PARTS & SERVICE NEWS

REF NO.	AA09095
DATE	July 1, 2009

SUBJECT: STEERING BLEEDDOWN MANIFOLD FITTING IMPROVEMENT**PURPOSE:** To inform the field of a kit to improve the reliability of the hydraulic piping fitting installed in the bleeddown manifold.**APPLICATION:** Komatsu Electric Drive Dump Trucks:
830E-1AC: A30240 - A30302**FAILURE CODE:** 6A0037**DESCRIPTION:**

SUBJECT: STEERING BLEEDDOWN MANIFOLD FITTING IMPROVEMENT

FIGURE 1. CURRENT DESIGN

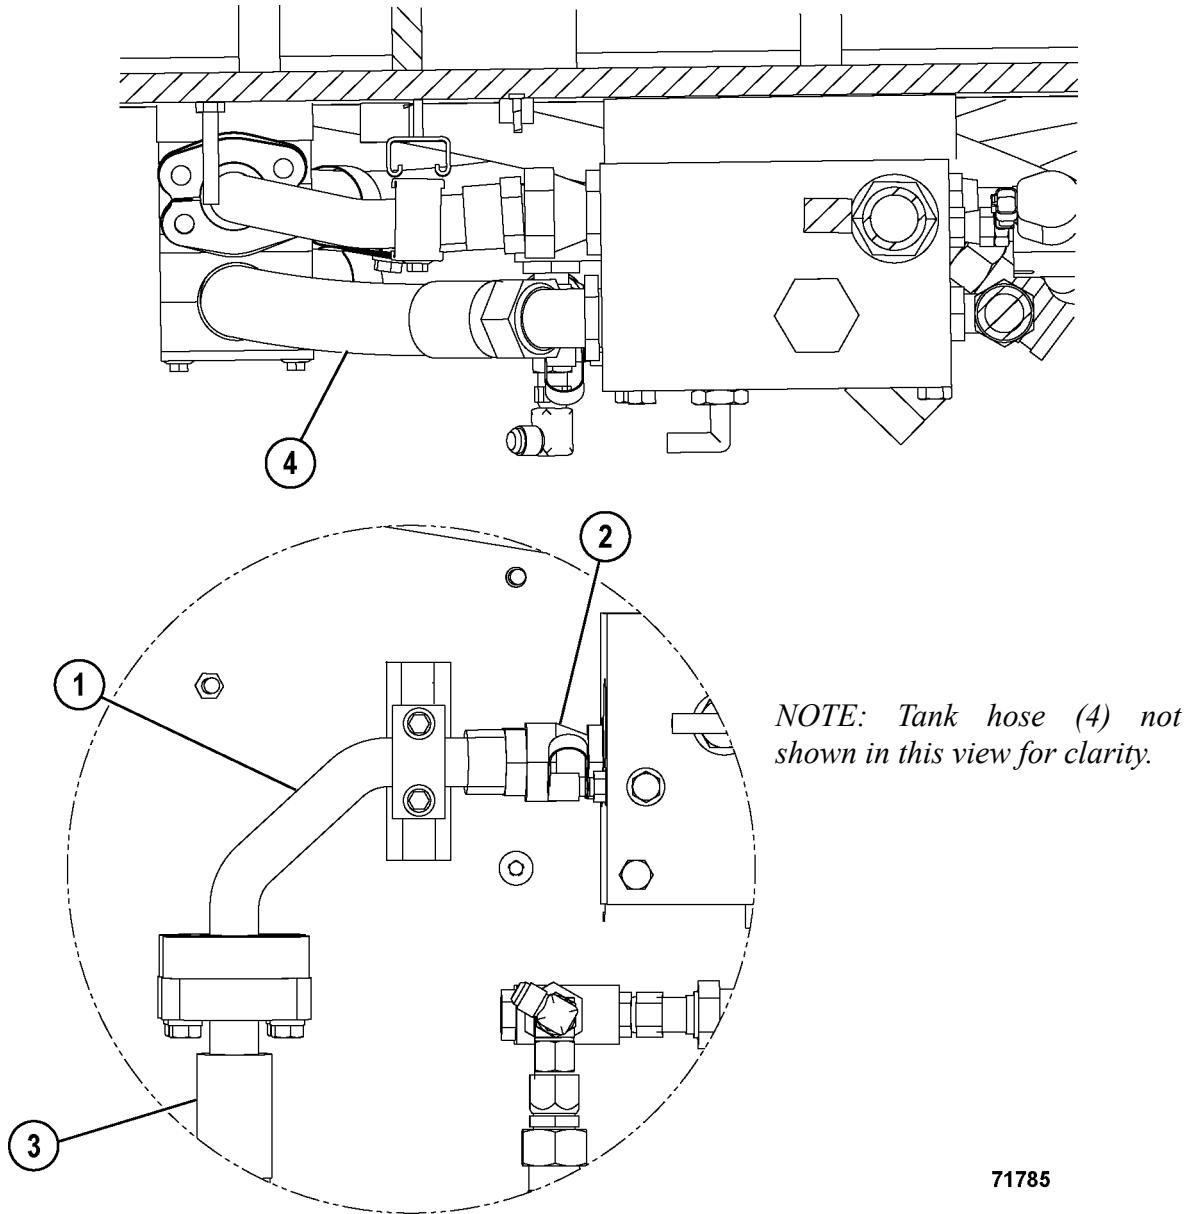
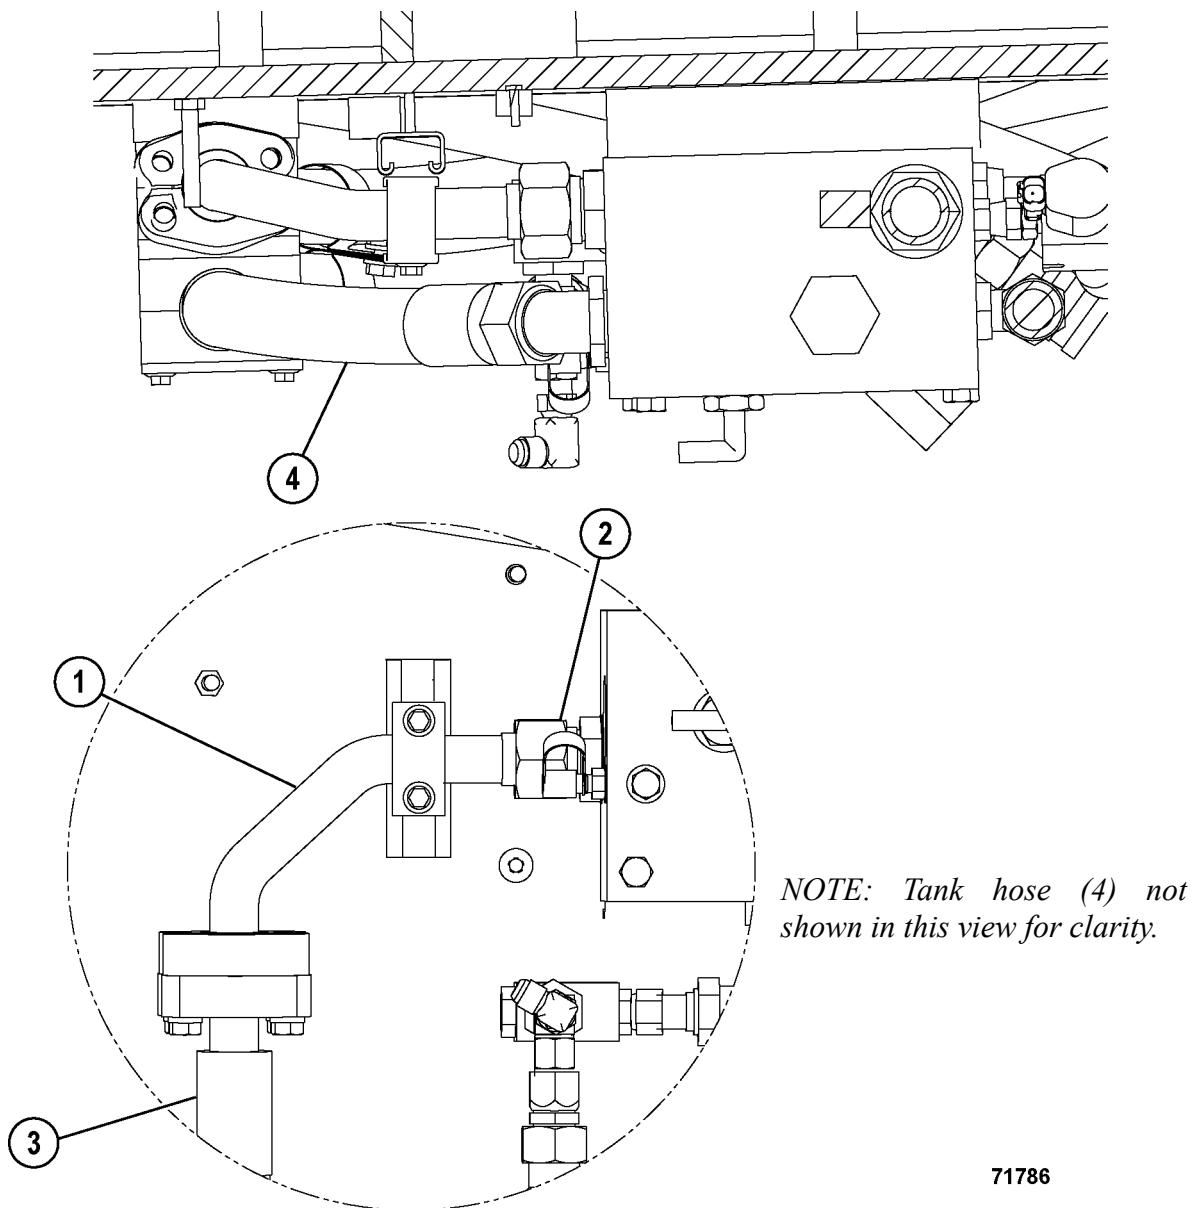
Some trucks in operation may experience a hydraulic oil leak at flare fitting (2, Figure 1). Current flexing of supply tube (1) can exert excess stress on fitting (2). This excess stress can cause a failure of this fitting.

Steering Tube Kit (XK0865) has been developed to replace the existing supply tube with a new tube (1, Figure 2) and fitting (2). The flare fitting is replaced with an O-ring face seal fitting. This new supply tube and fitting combination will improve the reliability of the fitting and lines. The tank hose and fitting located to the outside of the supply hose will not need to be replaced.

FIGURE 1. CURRENT DESIGN
(SOME PARTS REMOVED FOR CLARITY)

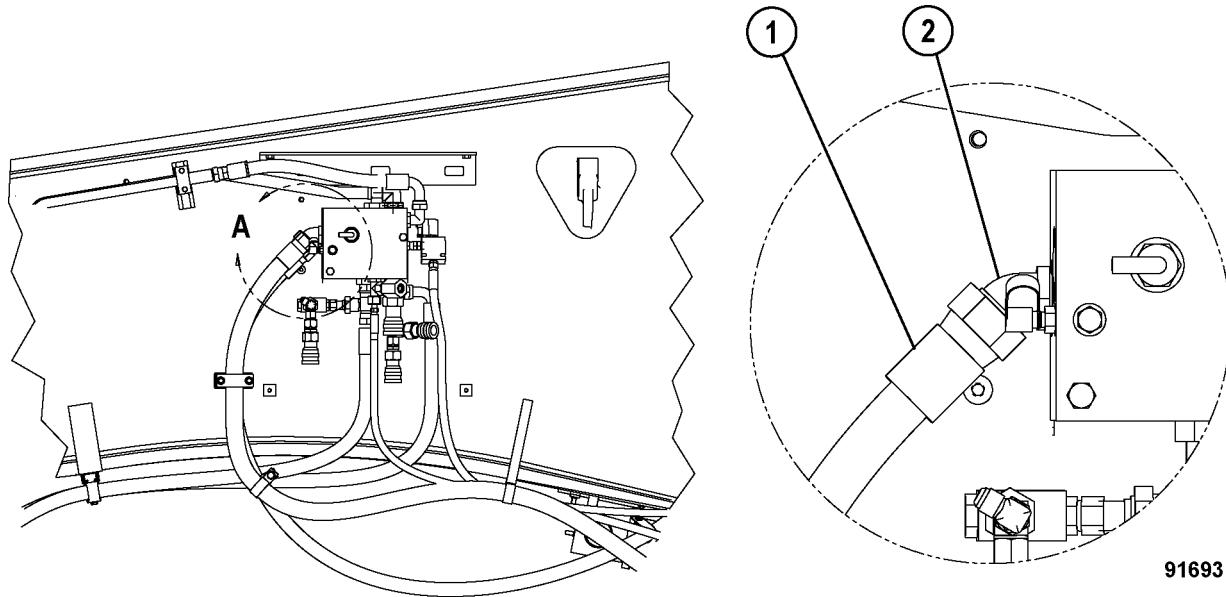
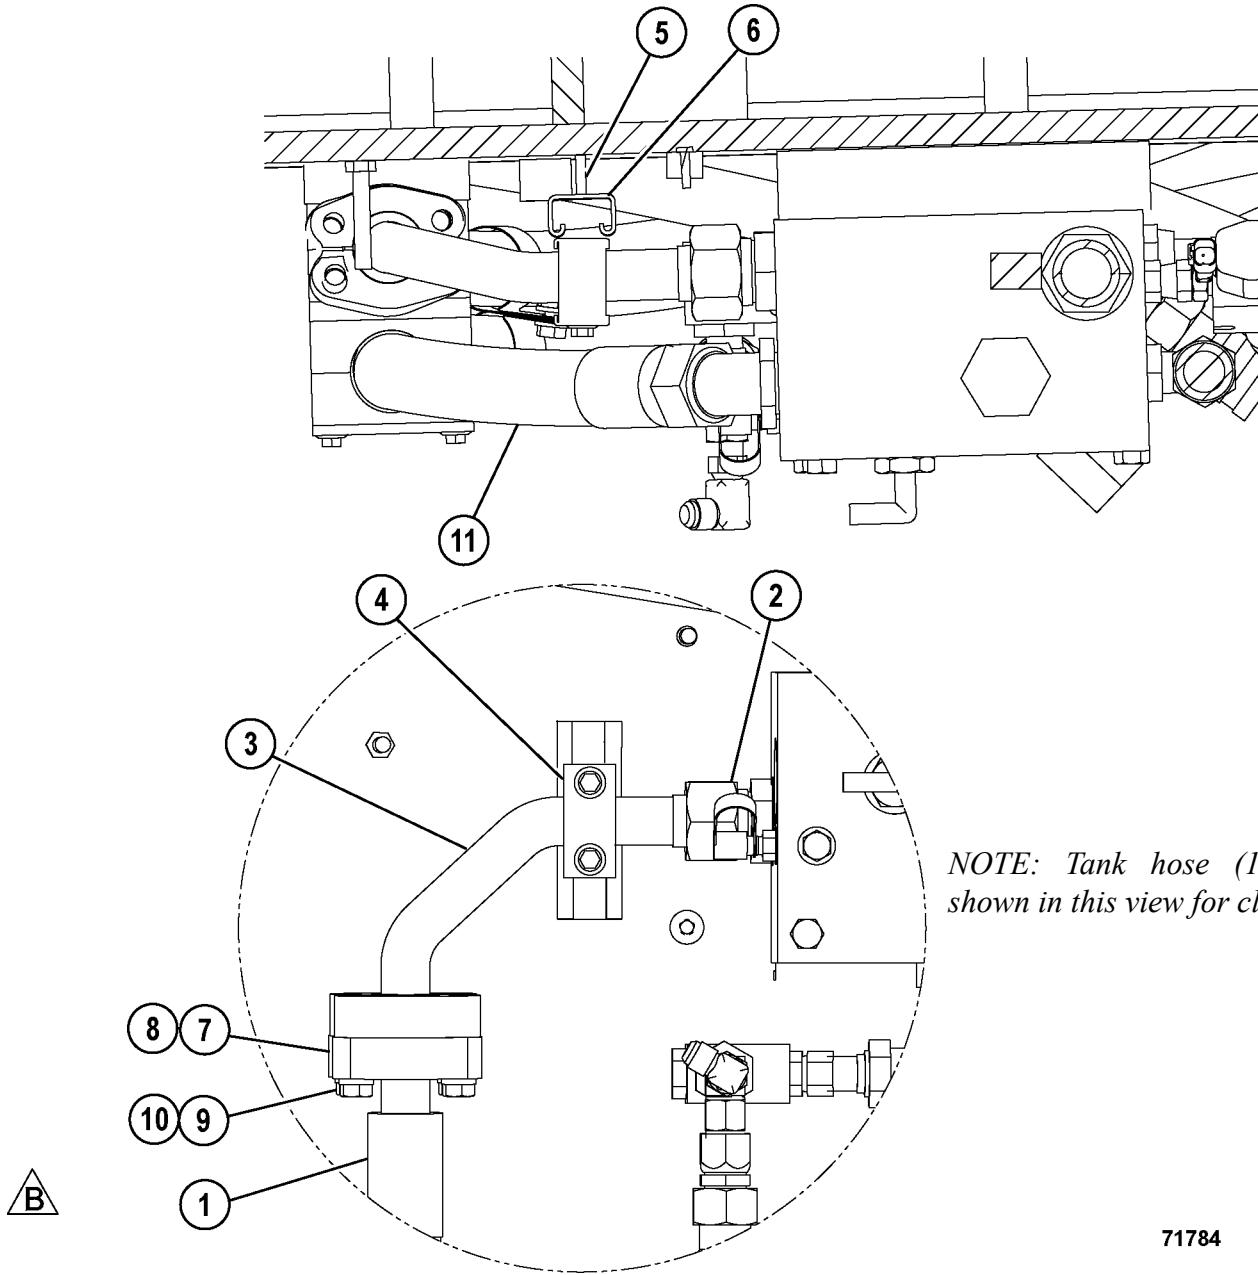
Some trucks in operation may experience a hydraulic oil leak at elbow fitting (2, Figure 1). Current routing of supply hose (1) can exert excess stress on elbow fitting (2). This excess stress can cause a failure of this fitting.

Steering Tube Kit (XK0853) has been developed to replace the existing supply hose with a new hose (1, Figure 2) and tube (3) with additional clamping for the tube. The elbow fitting is replaced with a straight fitting. This new supply hose, tube, clamping and fitting combination will improve the reliability of the fitting and line. The tank hose and fitting located to the outside of the supply hose will not need to be replaced.
